STATE OF UTAH
DEPARTMENT OF NATURAL RESOURCES
DIVISION OF OIL, GAS AND MINING

2. NAME OF OPERATOR: WESTPORT OIL & GAS COMPANY, L.P.			9. WELL NAME and NUMBER: NBU 1021-28G	
3. ADDRESS OF OPERATOR: 1368 S 1200 E CITY VERNAL STATE UT ZIP 84078		PHONE NUMBER: (435) 781-7060	10. FIELD AND POOL, OR WILDCAT: NATURAL BUTTES

**DIVISION OF OIL, GAS AND MINING
APPLICATION FOR PERMIT TO DRILL
STATEMENT OF BASIS**

THE OPERATOR REQUESTS AUTHORIZATION TO CHANGE THE LOCATION LAYOUT AND CUT SHEETS.

LOCATION LAYOUT FOR

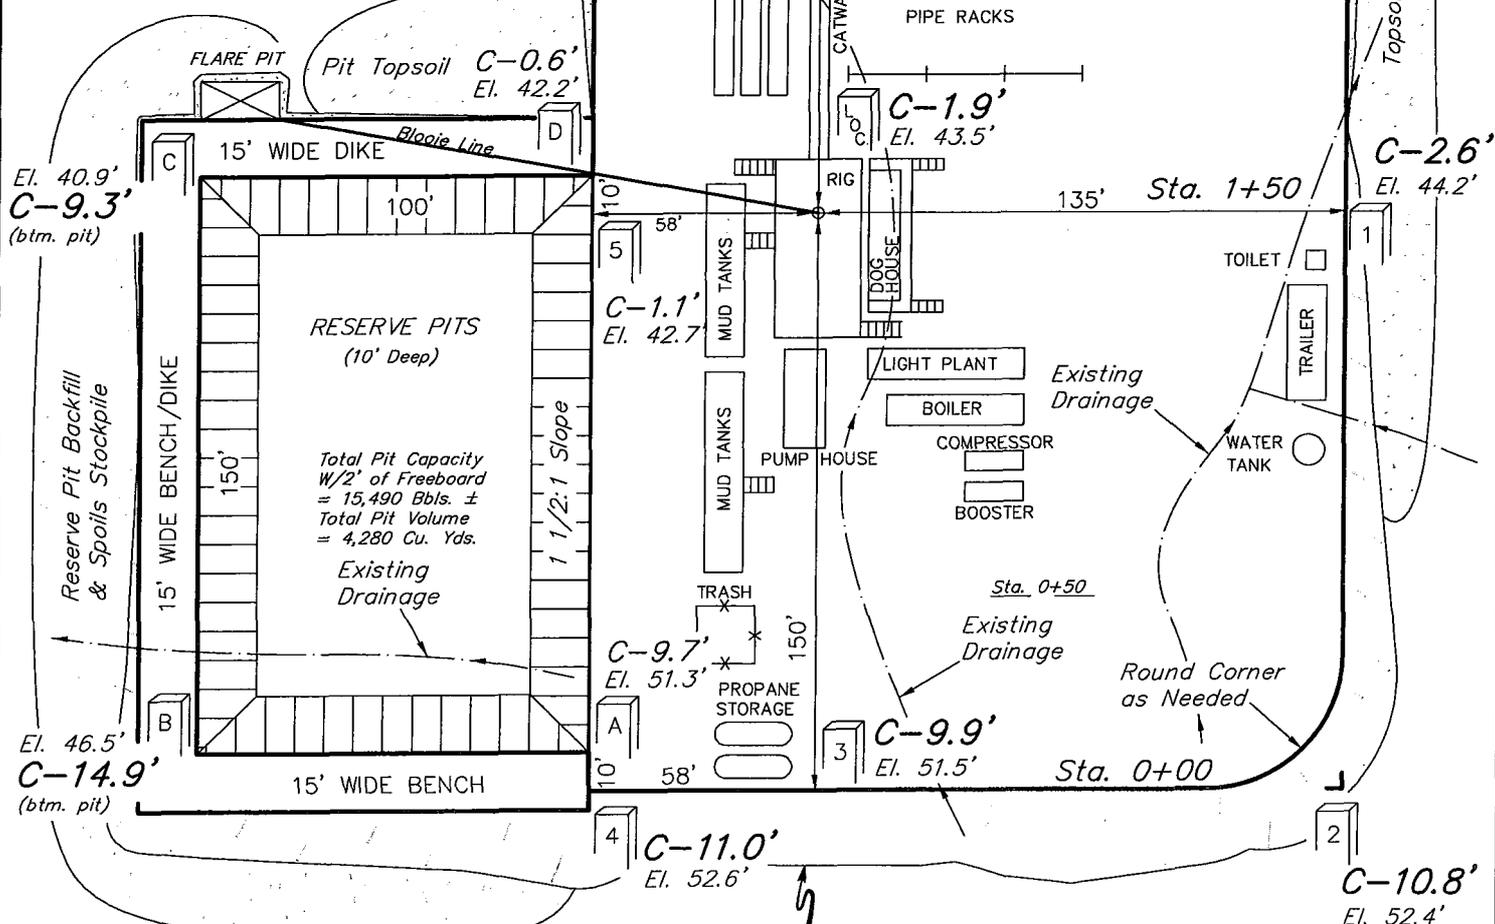
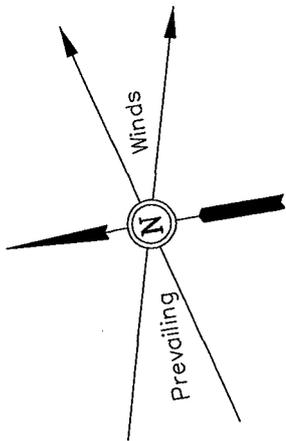
This location will be turned 90 degrees from the surveyed description to allow for easier access and less location construction. A new Plat "D" and "Location Layout" sheet will be provided with a sundry explaining this change.

PLEASE REFER TO THE REVISED LOCATION LAYOUT AND CUT SHEETS.
